# Proposed Variation No. 1 of Kilkenny City & Environs Development Plan 2014-2020

Chief Executive's Report  
on Submissions received

**Kilkenny County Council  
July 2015**

**Figure 3.4 Variation No. 1**

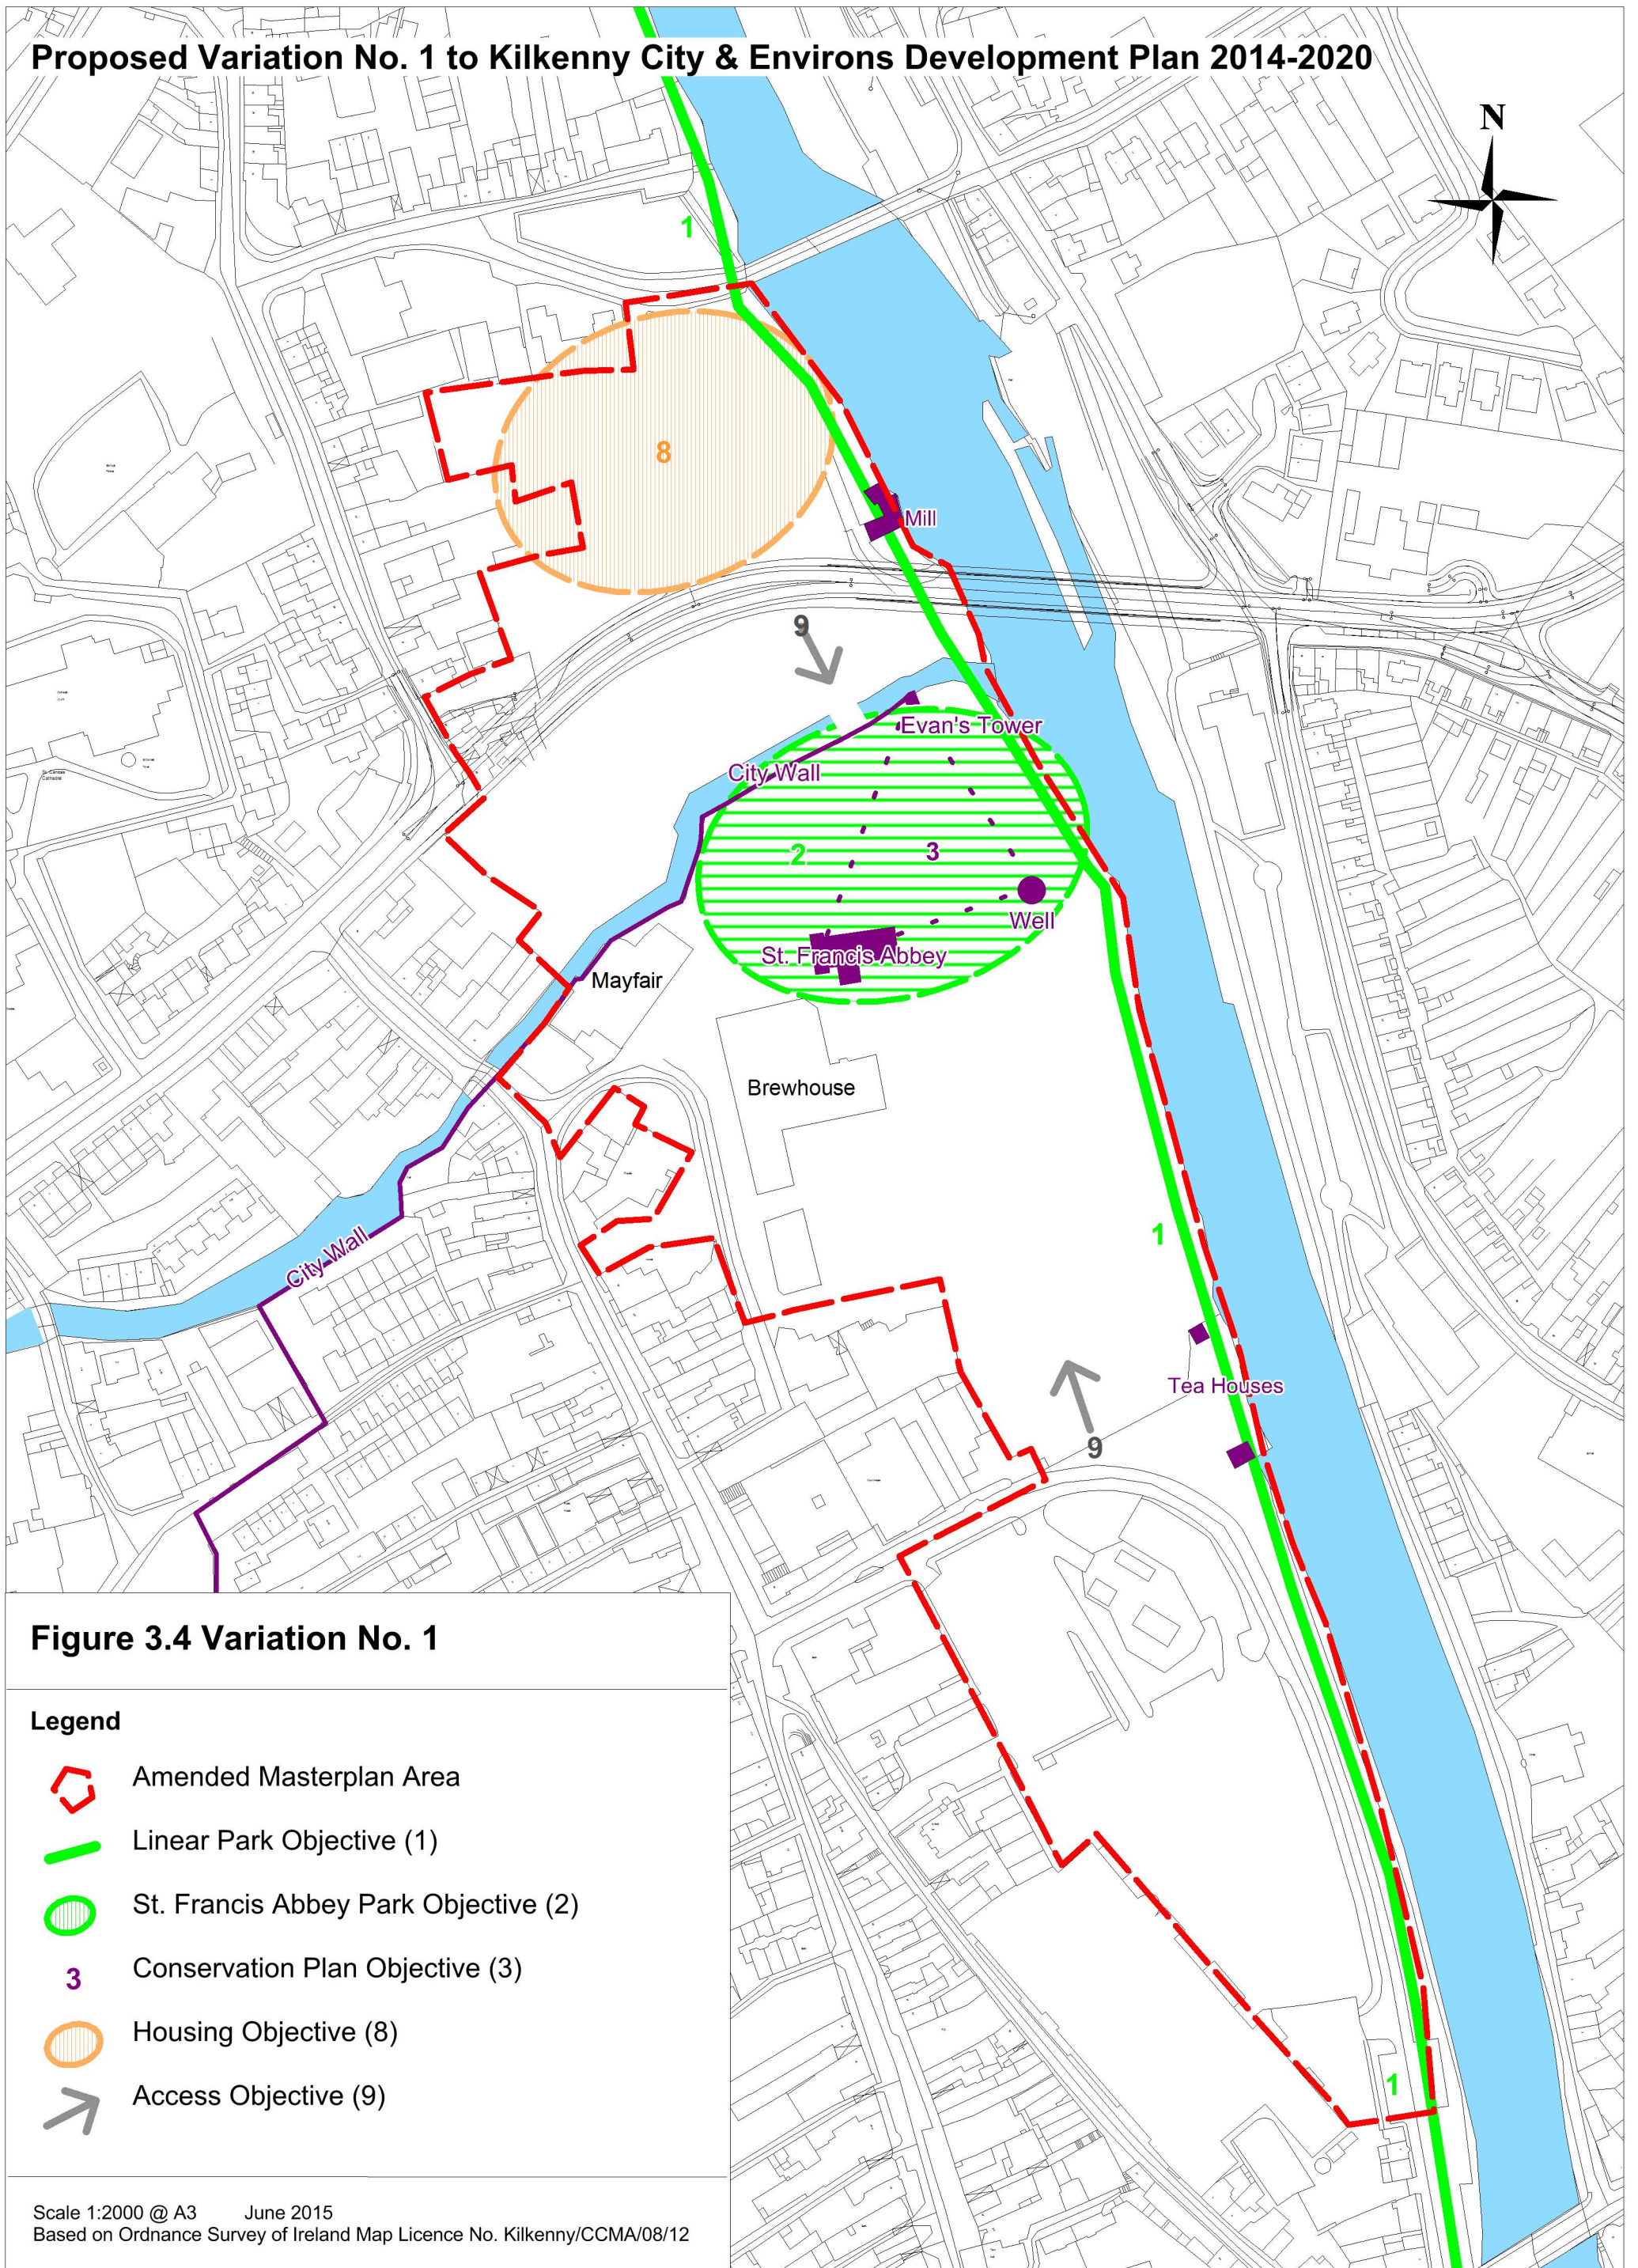
8. To provide for housing within the masterplan in the area north of the Central Access Scheme as identified on fig 3.4
9. To provide for an urban street of pedestrian and cyclist priority between the Central Access Scheme and Bateman Quay crossing the River Breagagh at the existing bridge crossing. To provide for traffic management measures on the street such as to inhibit the flow of through traffic and heavy goods vehicles.

<p>11. The Department is concerned regarding any potential visual impact the proposed ramped access from the Central Access Scheme (CAS) to the Framework Plan area may have on the setting and amenity of the adjacent National Monuments (St Francis Abbey and City Defences, Evans Tower) and the nearby St. Canice's Cathedral and ecclesiastical site. This matter should be addressed in any landscape assessment carried out as part of the Framework Plan. Details regarding any required Part 8 applications or other permissions should be provided in the final Framework Plan</p> <p>12. In the consideration of alternative scenarios regarding access for the Masterplan/Framework area, it has been noted that development options will be examined including for transport. It is important that the various options for proposed access points (i.e. road access, emergency access, pedestrian access, bridge, etc.) be archaeologically assessed to ensure that the access points and proposed roadways/streets within the Framework Plan area are positioned, designed and constructed to ensure the preservation and protection of both the amenity and physical remains (both above and below ground) associated with the National Monuments located within the Plan area.</p> <p><b>Nature Conservation</b></p> <p>13. This proposed variation is to allow for the proposed Masterplan for the Abbey Creative Quarter. The SEA is therefore similar to that for the proposed Masterplan and the natural heritage comments of this Department are therefore the same as outlined below. However while a NIR was produced for the proposed Masterplan only an appropriate assessment (AA) screening was carried out for the proposed variation.</p> <p>14. While overall the SEA is comprehensive with respect to the natural heritage it has unfortunately been restricted to looking at designated sites within a 15km radius, which is a rule of thumb often used for Plans but is not suitable for rivers, where a whole catchment may need to be included.</p> <p>15. The indicator for B1 in the SEA has been restricted to the article 17 reports of this Department which does not include birds. In addition objective B3 has only included compliance with the Wildlife Acts 1976-2010 with regard to the protection of species in schedule 5. This means that birds and plants have been omitted. All wild birds are protected under the Wildlife Acts and protected plants are listed in SI 274 of 1987.</p> <p>16. The SEA refers to a habitat survey which indicates the habitats to be impacted are "River Nore" and "grassy banks". The photographs in the Masterplan appear to indicate that some of the river is bounded by wall but that some still has riverbank vegetation. Such vegetated areas are important refuges for biodiversity and may be used by otters. Prior to any final design for the linear park, which is part of the proposed Variation 1, an ecological survey / ecological impact assessment (EclA), will be necessary to ensure no negative impacts on the ecological corridor or species such as otter and kingfisher, listed on the annexes of the Habitats and Birds Directives respectively.</p>

11. The visual impact of the proposed access onto the CAS for the proposed urban street will be assessed during the detailed design process and at planning consent stage. Part 8 documentation has not been prepared for the access from the CAS to the proposed urban street.
